**THRUSH AIRCRAFT, INC.**

## **No. SB-AG-45 Rev. C**

### **FIN SPAR & ATTACH FITTINGS INSPECTION AND UPGRADE**

**Figure 45-1: Location of Attach Fittings**

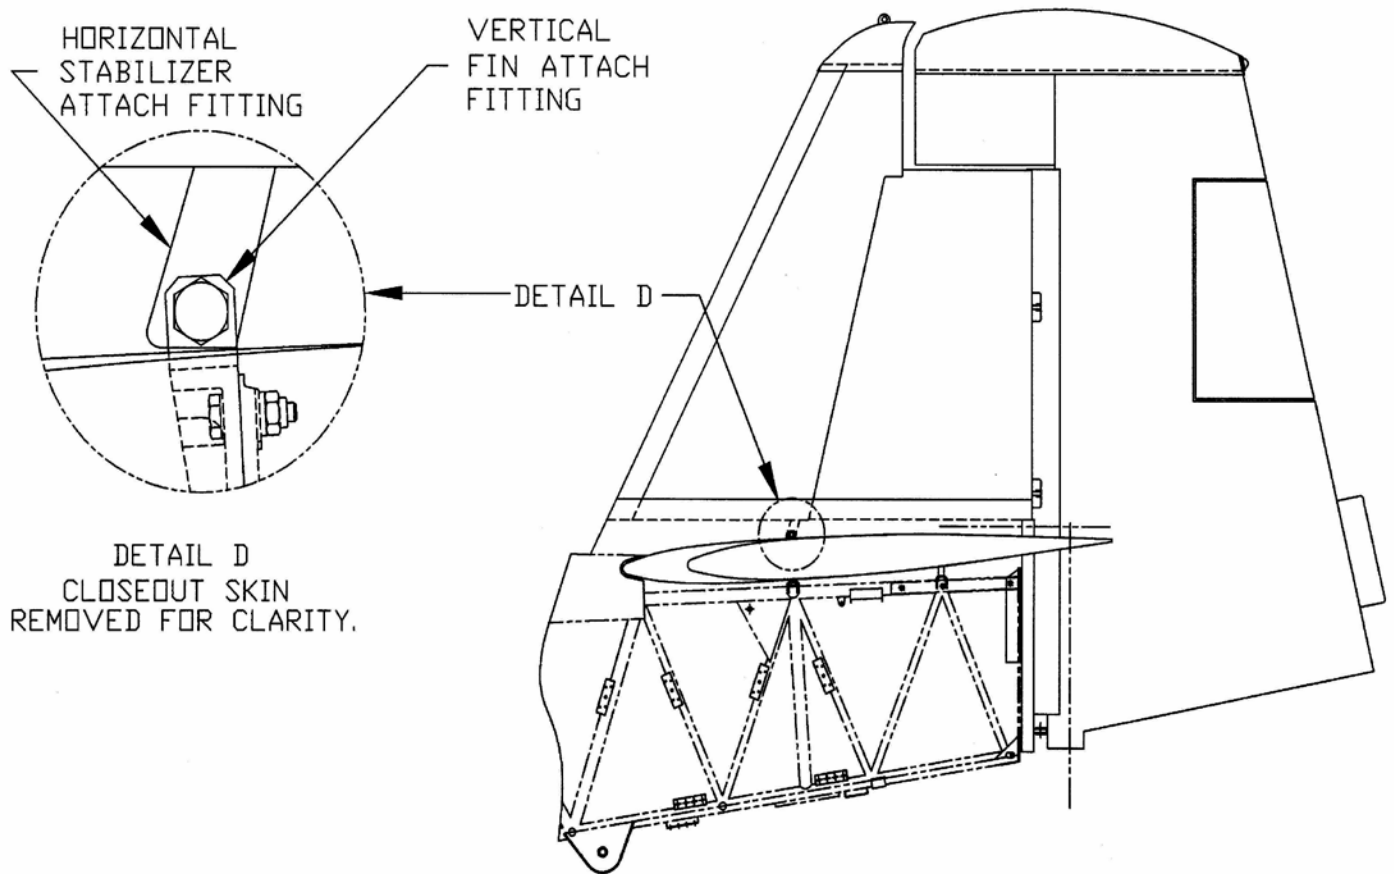
Inspection of the 40301-7 vertical stabilizer attach fitting, 40303-1, 4 or 7 horizontal stabilizer attach fitting (95267-1 on the T660) and bolt must be accomplished immediately upon receipt or downloading of this service bulletin. It must be re-inspected every 100 hours thereafter until they are replaced with the 95266-11 vertical fin attach fitting, 95267-5 horizontal stabilizer attach fitting, and larger bolt per SB-AG-45 Rev. C. See Figure 45-1 for the location of these fittings and bolt.

**Figure 45-2: Inspect Vertical Fin Spar Assy., Using a 10X magnifier at the Upper Attach Bolts**

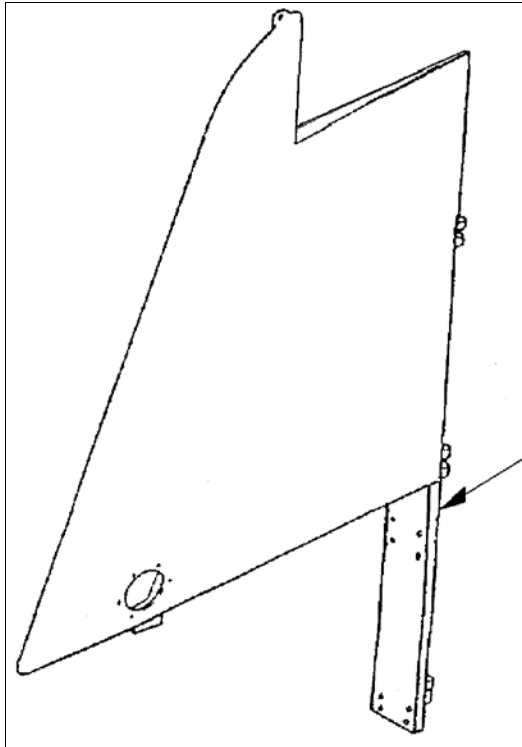
Remove the rudder from the aircraft. Remove vertical fin fairings, dorsal fin if installed, and the top four bolts attaching the aft vertical stabilizer spar to the fuselage frame. Loosen the bottom four bolts attaching the aft vertical stabilizer spar to the fuselage. While in this area, carefully inspect the vertical fin aft spar for cracks, using a 10X magnifier, especially in the area between the top attach bolts and the center rudder hinge (Ref. Fig. 45-2). Repair, replace and/or refinish the aft spar as necessary.

**Figure 45-3: Areas of vertical fin attach fitting to be inspected for cracks**

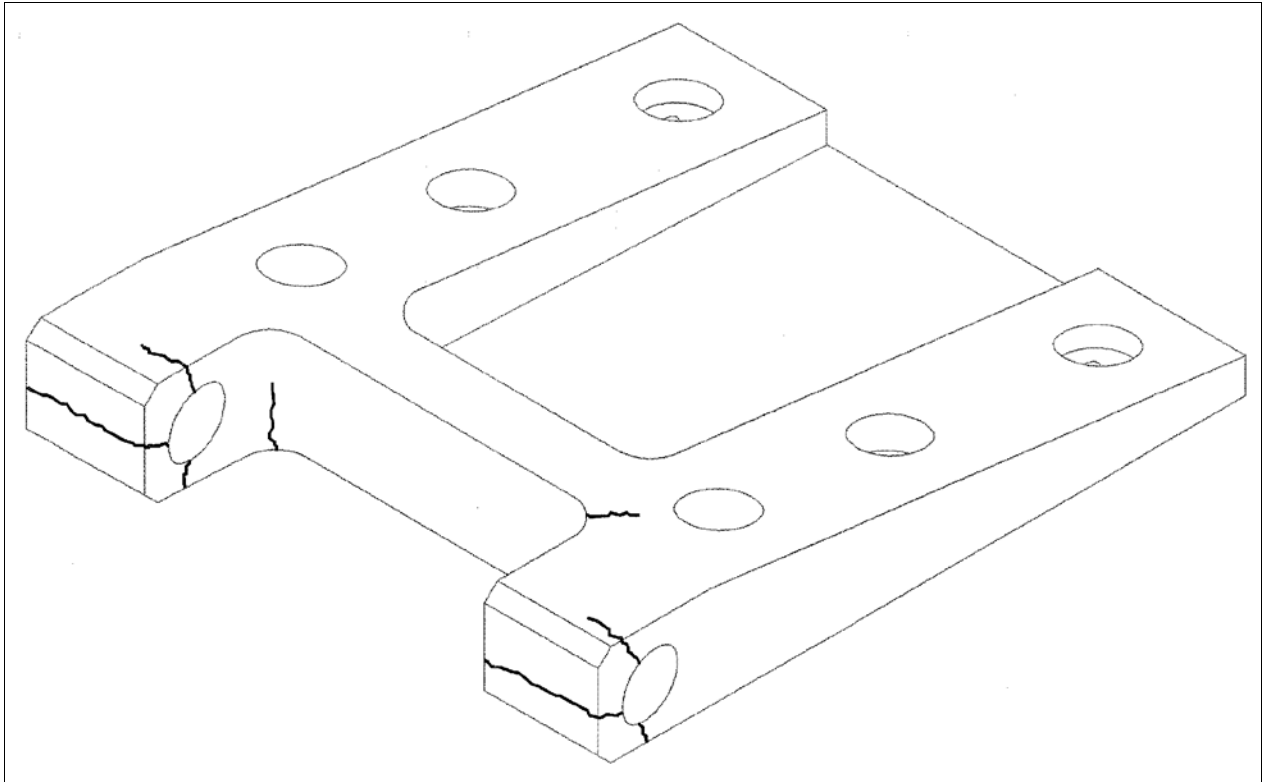
Remove the bolt holding the horizontal stabilizer attach fitting, 40301-7 (95266-1 for the T660), to the vertical fin\_attach fitting on the horizontal stabilizer. **(This terminology may be confusing. The vertical fin attach fitting is on the horizontal stabilizer, and the horizontal stabilizer attach fitting is on the vertical fin.)** Tilt the vertical fin aft until the inner faces of the horizontal stabilizer attach fitting lugs are easily visible. Block the vertical fin in this position with wood blocks. Using a 10X magnifier, visually inspect both lugs of the vertical fin attach fitting on the horizontal stabilizer and the rest of its exposed surfaces for cracks. If the paint is cracked, discolored or bubbled, remove loose paint prior to inspection, as this can hide cracks or corrosion. Also inspect the inside of the holes as much as possible. See Figure 45-3 for areas most suspect for cracks.

**Figure 45-4: Use of Hole Transfer Fixture ESK 708-14/15 for Stabilizer Attach Fitting**

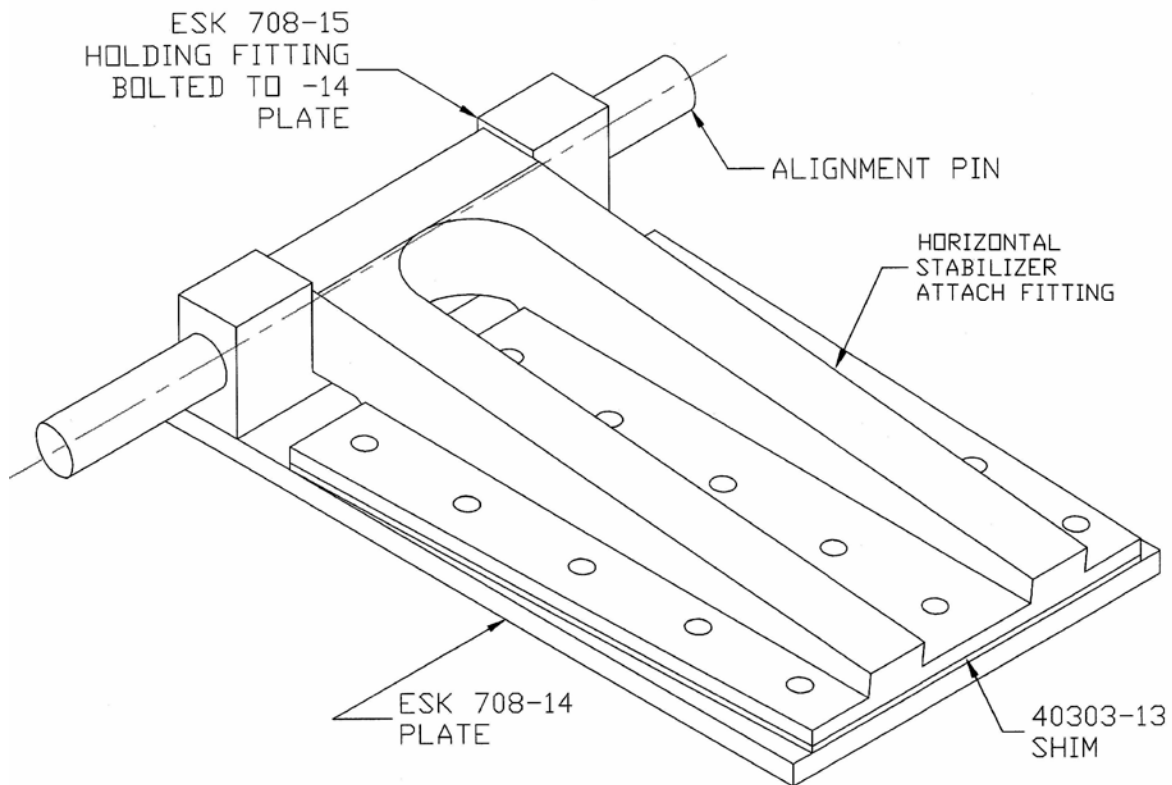
5. Install old horizontal stabilizer attach fitting, removed from the vertical fin, on the -14/15 holding fixture using a 6" 5/16" (7/16" if SB-AG-45 has been complied with) pin or drill shank for alignment (see Fig. 45-4). Using a suitable "C" clamp, clamp the fitting to the plate. If the old fitting is a steel weldment, drill #30 through the 15 holes (3 rows of 5 ea.) nearest to the tube at the top of the steel fitting, using the old steel fitting as a drill jig. Do not drill the large holes in the steel attach fitting. Remove the old steel fitting and discard it.

6. Install the new P/N 95267-5 horizontal stabilizer attach fitting onto the -14/15 holding fixture just drilled using a 7/16" alignment pin or 6" 7/16" drill shank (see Fig. 45-4). The new 40303-13 shim installs between the fitting and the plate. Using "C" clamps, clamp the new aluminum horizontal stabilizer attach fitting and shim to the -14 plate.

**Figure 45-5: Use of Hole Transfer Fixture for Vertical Fin Fitting**

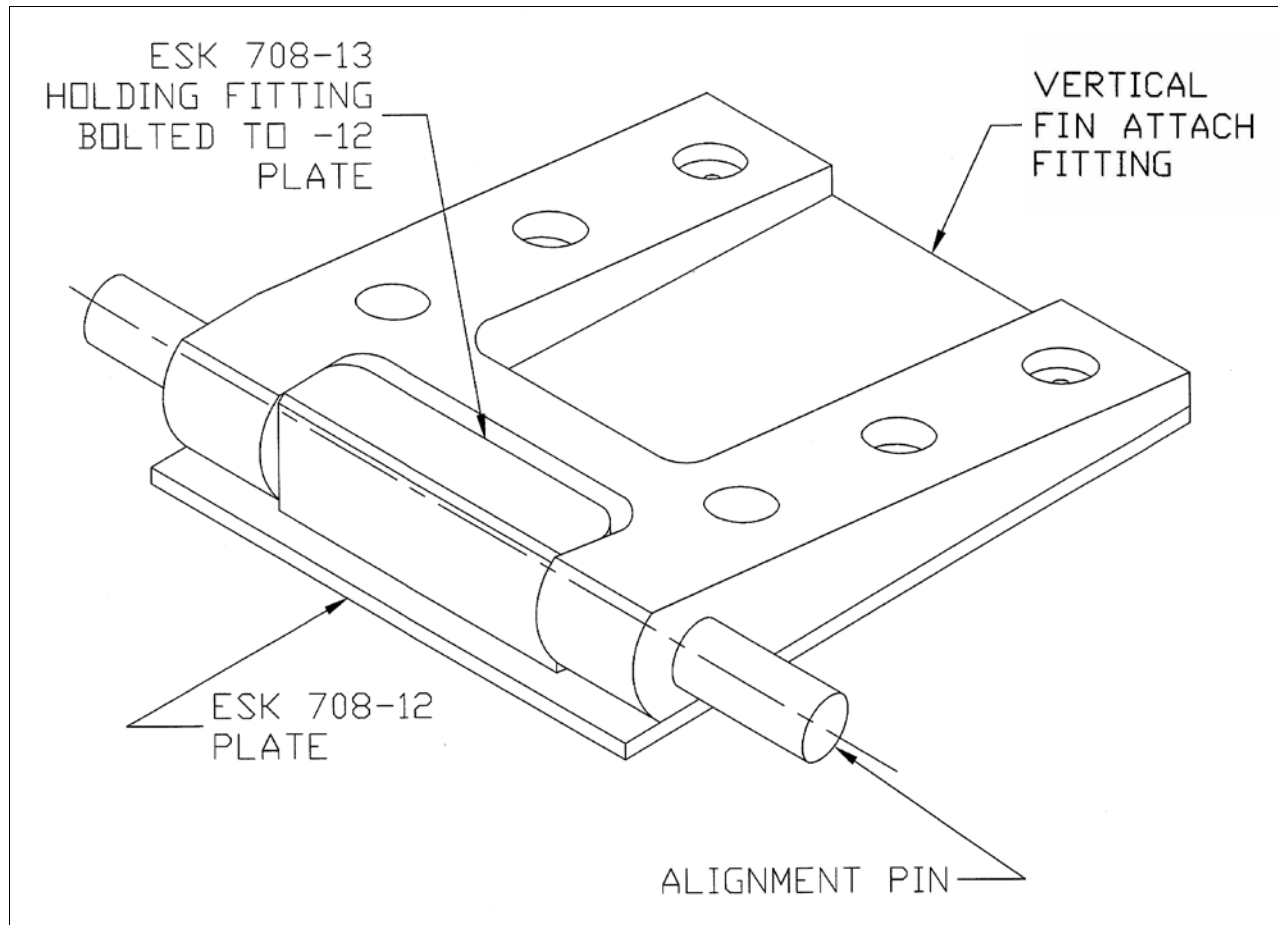
7. Through the bottom access holes in the horizontal stabilizer, remove the existing vertical fin attach fitting. Inspect the horizontal stabilizer forward spar for condition and corrosion and repair and/or refinish as necessary. Note any holes that need to be enlarged for clean-up. Corresponding holes in the new fitting must be enlarged after the holes have been drilled per step 8.
8. The hole pattern of the old vertical fin attach fitting must be transferred to the new 95266-11 vertical fin attach fitting. The #11 holes have been left out of the 95266-11 for this purpose. Tool ESK708-12/13 serves to ensure that the hole pattern in 95266-11 matches the hole pattern in the horizontal stabilizer spar. See Figure 45-5 for use of this tool.

The ESK 708-13 holding fitting is attached to the ESK 708-12 plate with two NAS 1203-2 bolts. Install an ESK 708-17 bushing in the -13 holding fitting if SB-AG-45, installing a 7/16" bolt, has not been complied with. The vertical fin attach fitting previously removed is attached to the ESK 708-13 fitting with a 5/16" pin or drill shank. Once installed on the -13 fitting, clamp the old vertical fin attach fitting to the -12 plate. Drill six #11 holes in the -12 plate using the old vertical fin attach fitting as a drill template. Remove the old vertical fin attach fitting and discard it. Deburr the -12 plate and remove the ESK 708-17 bushings. Install the new 95266-11 fitting on the -12/13 holding fixture using a 7/16" pin or drill bit shank and C-clamps. Turn this assembly over and back-drill the 95266-11 fitting #11 six places using the -12 plate as a drill template. Remove the 95266-11 fitting and deburr the holes. Discard the ESK 708-12 plate. The ESK 708-13 holding fitting may be used for another airplane by locally fabricating a new ESK 708-12 plate (see Fig. 45-6).

**Figure 45-6: Hole Pattern Transfer Plates. Material .100-.188 Aluminum**

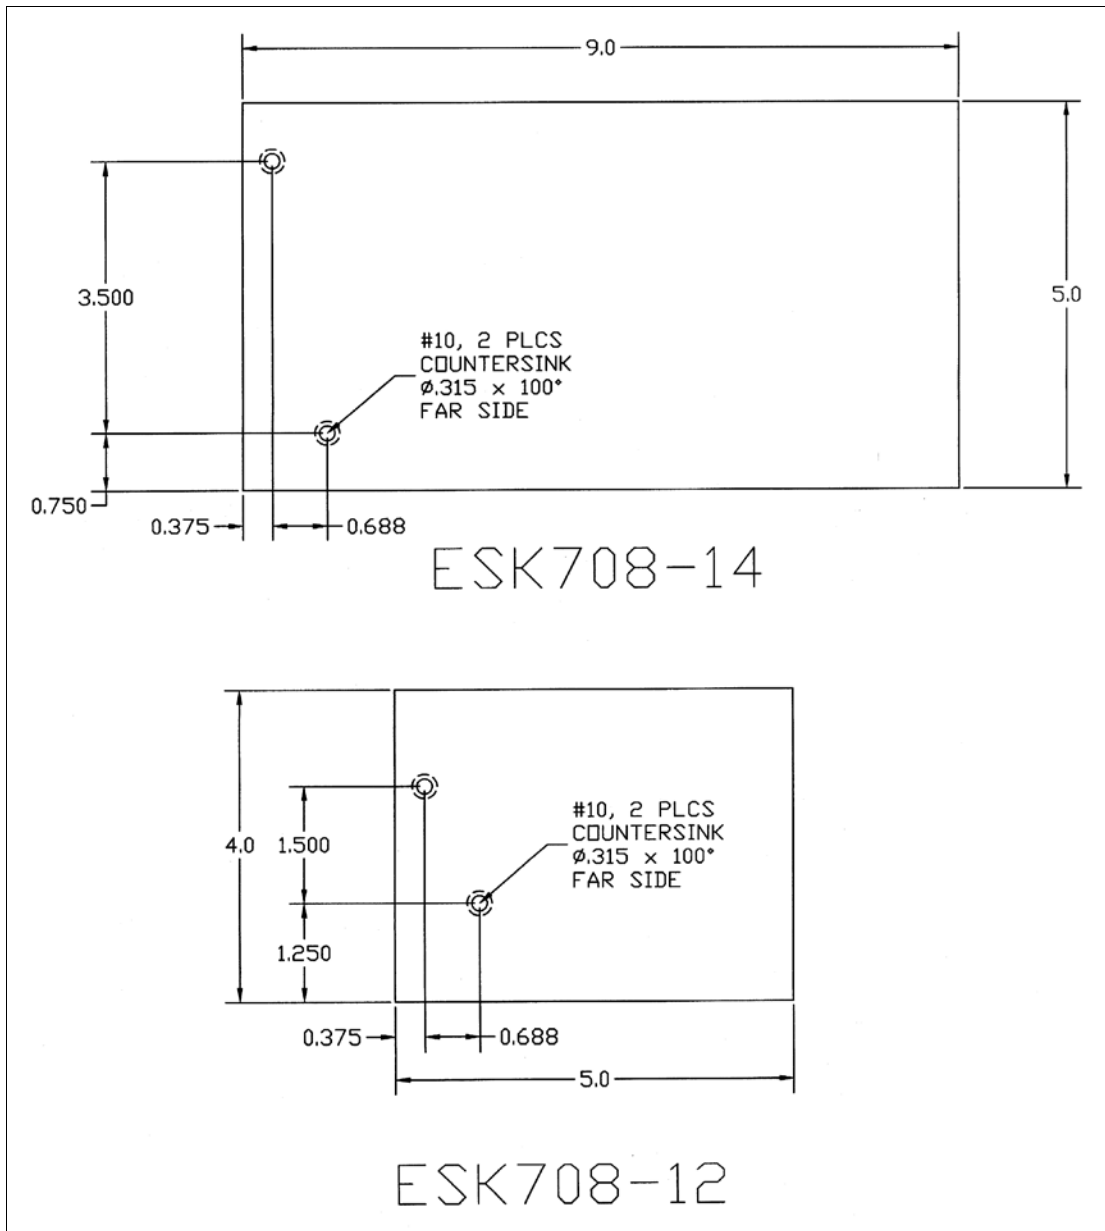
Invert this assembly and back drill the #30 holes through the new aluminum fitting and shim, using the -14 plate as a drill template. Remove the aluminum fitting and shim from the fixture and discard the -14 plate. Deburr new aluminum fitting and shim. Note that the -15 holding fitting may be used to do another airplane by locally fabricating a new -14 plate (see Fig. 45-6).
